APPLICATION NO.	FILING DATE	FIRST NAMED INVENTOR	ATTORNEY DOCKET NO.	CONFIRMATION NO.
10/626,463	07/24/2003	Douglas Barry		1322
75	90 06/20/2006		EXAMI	INER
George R. Nimmer			DILLON JR, JOSEPH A	
PO Box 252				
Omaha, NE 68101-0252			ART UNIT	PAPER NUMBER
,			3651	
			DATE MAILED: 06/20/2006

Application No.	Applicant(s)			
Office Action Summary		10/626,463	BARRY ET AL.			
		Examiner	Art Unit			
		Joseph A. Dillon, Jr.	3651			
Period f	The MAILING DATE of this communication app or Reply	ears on the cover sheet with the c	orrespondence address			
A SHORTENED STATUTORY PERIOD FOR REPLY IS SET TO EXPIRE 3 MONTH(S) OR THIRTY (30) DAYS, WHICHEVER IS LONGER, FROM THE MAILING DATE OF THIS COMMUNICATION. - Extensions of time may be available under the provisions of 37 CFR 1.136(a). In no event, however, may a reply be timely filed after SIX (6) MONTHS from the mailing date of this communication. - If NO period for reply is specified above, the maximum statutory period will apply and will expire SIX (6) MONTHS from the mailing date of this communication. - Failure to reply within the set or extended period for reply will, by statute, cause the application to become ABANDONED (35 U.S.C. § 1

Replacement Sheet Title: Conveyor Track Drive Inventor: Barry et al. Serial No.: 10/626,463

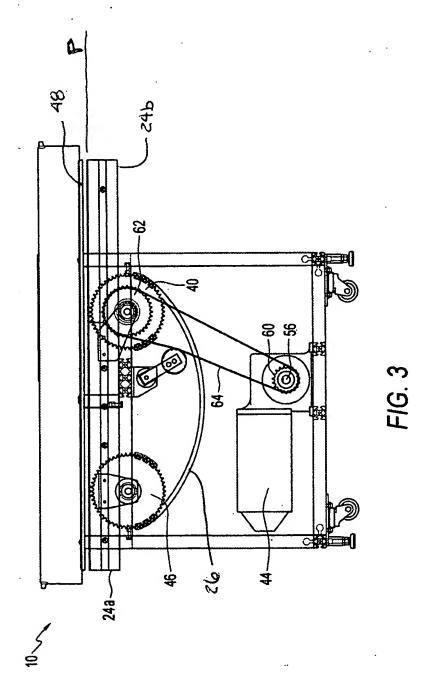
In the original disclosure, element 48 had not been indicated in the original drawings. Additionally, element 52 was incorrectly indicating a feature. Further, element 50 was not originally depicted in such as way as to make clear it was actually in the plane P. For at least these reasons the original disclosure didn't clearly indicate that

the housing upper end, the guide, element 48 and the plane P were all coplanar and substantially the same feature.

Also, that the side walls of the track were not originally indicated as being coplanar.

In Figure(s) 4, it was not originally clear that what is now indicated as element 20 were the carriers.

Do Not Enter Ex Jillan

Replacement Sheet
Title: Conveyor Track Drive
Inventor: Barry et al.
Serial No.: 10/626,463

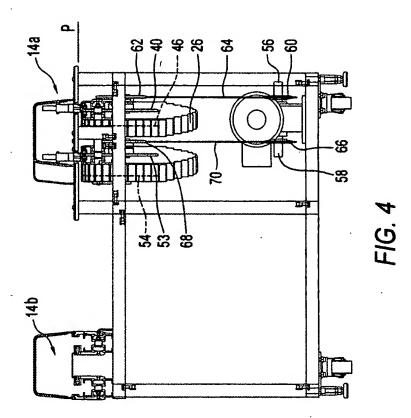
3. The proposed drawing corrections of 11/28/05 & 4/10/06 have not been entered as containing new matter.

However, the proposed drawing corrections show what the examiner sees as new matter.

Bo Enter Ex Dillon
